# UNITED STATES PATENT AND TRADEMARK OFFICE

10/760,253

<b>Office Action Summary</b>	<b>Application No.</b> 10/760,253	<b>Applicant(s)</b> SILVERBROOK ET AL.	
	<b>Examiner</b> LAURA E. MARTIN	<b>Art Unit</b> 2853

## DETAILED ACTION

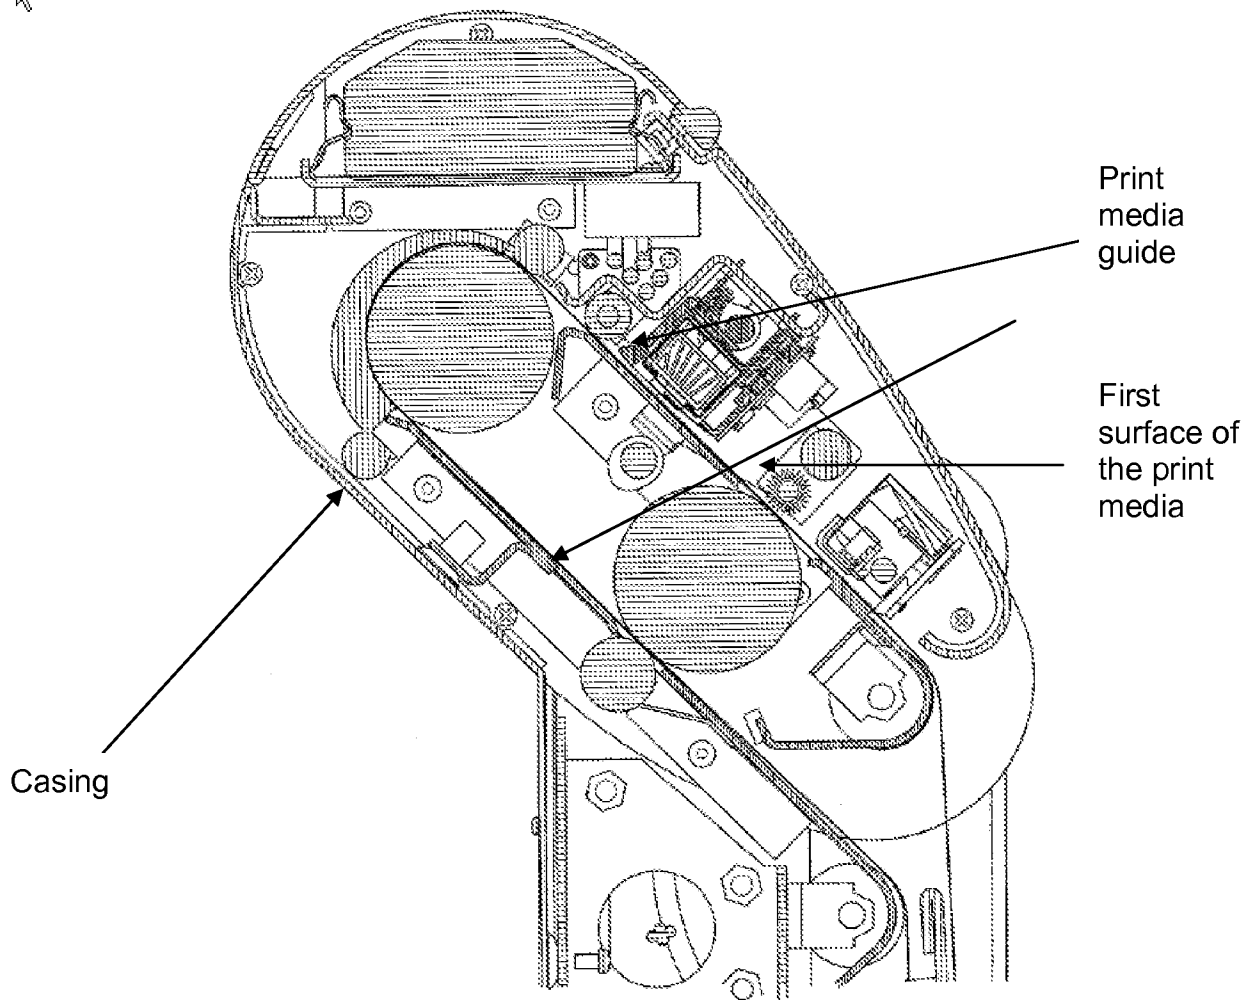
As per claim 1: a casing in which the at least one printhead module is removably mounted a print media guide mounted to a slanted portion of the casing immediately adjacent the channel, a print media guide mounted to a first sidewall so as to extend from the first sidewall and end before the nozzles, the print media guide being arranged to contact each moving portion of the first surface of the print media (shown below).

As per claim 2: a print media guide is arranged to substantially prevent the print media from impinging on the nozzles of each of the at least two printhead integrated circuits (see figure below – media guide (triangular part before nozzles) and rollers put pressure on paper so that it rests against the media guide and not the nozzle area).

As per claim 3: the print media guide is arranged to provide a gap between the nozzles of each of the at least two printhead integrated circuits and the passing print media (see figure below – media guide and rollers put pressure on paper so that it rests against the media guide and not the nozzle area).

Applicant's arguments filed 11/5/08 have been fully considered but they are not persuasive. Applicant argues that the amended claims are not taught by the cited references; however the examiner disagrees. The examiners reading of the claims upon the prior art is disclosed in the rejection above. The triangular part before the first sidewall of the printhead helps guide the media. See above figure for details.
